MARINE ENERGY TEST AREAS – PHASE 2

Clarification Report

EOR0769
Clarification Report
Rev01
08 June 2020

The information included in this Clarification Report is a response to NRW's request for clarification/further information (dated 15 May 2020) on the Environmental Statement (ES) and supporting documents in support of an application for a Marine Licence (Licence Application No. ORML1957, submitted [19th December 2019]) for the META Project Phase 2 sites at Warrior Way (site 6), Dale Roads (site 7) and East Pickard bay (site 8).

Figure 6-1: Example wave rose for East Pickard Bay (site 8).

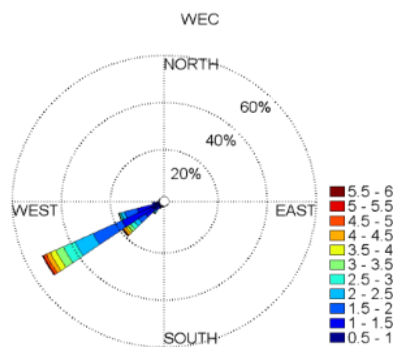
5.9.2.15 - NRW TE disagree with the conclusion that “The incoming waves at East Pickard Bay (site 8) approach from the south west therefore any disruption due to energy extraction within this site would occur between the wave device and the adjacent cliffs/coastline to the north of the site”. The wave climate in this location although dominated by waves from the SW will also have incident waves from the West. The assumption also does not take account of refraction and diffraction processes

around larger devices. Please provide consideration of the impact of this on your assessments.

6.4.1.1 The assessment of wave climate was based on the SEACAMS2 study undertaken at Swansea University (Yin *et al.*, 2018) cited in Table 5.2 of Chapter 5: Coastal Processes of the META Project Phase 2 ES. The study analysed the wave climate along the Pembroke coast and focussed on Freshwater West and St. Bride’s Bay. East Pickard Bay (site 8) is limited to a relatively narrow northerly stretch aligned with the coastline. The wave roses presented for East Pickard Bay (site 8) in Chapter 5: Coastal Processes do not exhibit waves approaching from due west. An example wave rose for East Pickard bay (site 8), to support this existing position, is shown in Figure 6-1 below.

- 6.4.1.2 Wave devices would also be aligned to capture energy from the principle wave direction (i.e. southwest). The wave climate to the south, beyond the boundary of East Pickard Bay (site 8), has increasing proportion of waves from the west with increasing distance.

- 6.4.1.3 In general terms, refraction and diffraction would be undesirable around wave power devices. For floating devices such as heave wave absorbers and attenuators this would reduce the efficiency of the device. Other floating devices are often articulated to move with the water surface and therefore disturbance is limited by the design criteria itself. For this reason, it was not included in the assessment as device selection and design would mitigate these parameters. Furthermore, some of the largest devices are bed mounted, such as the Bombora device which is proposed for the site, therefore this does not become an issue. The Applicant is therefore confident that the information considered and presented within Chapter 5: Coastal Processes of the META Project Phase 2 ES is sufficiently precautionary to inform the assessment of significance.
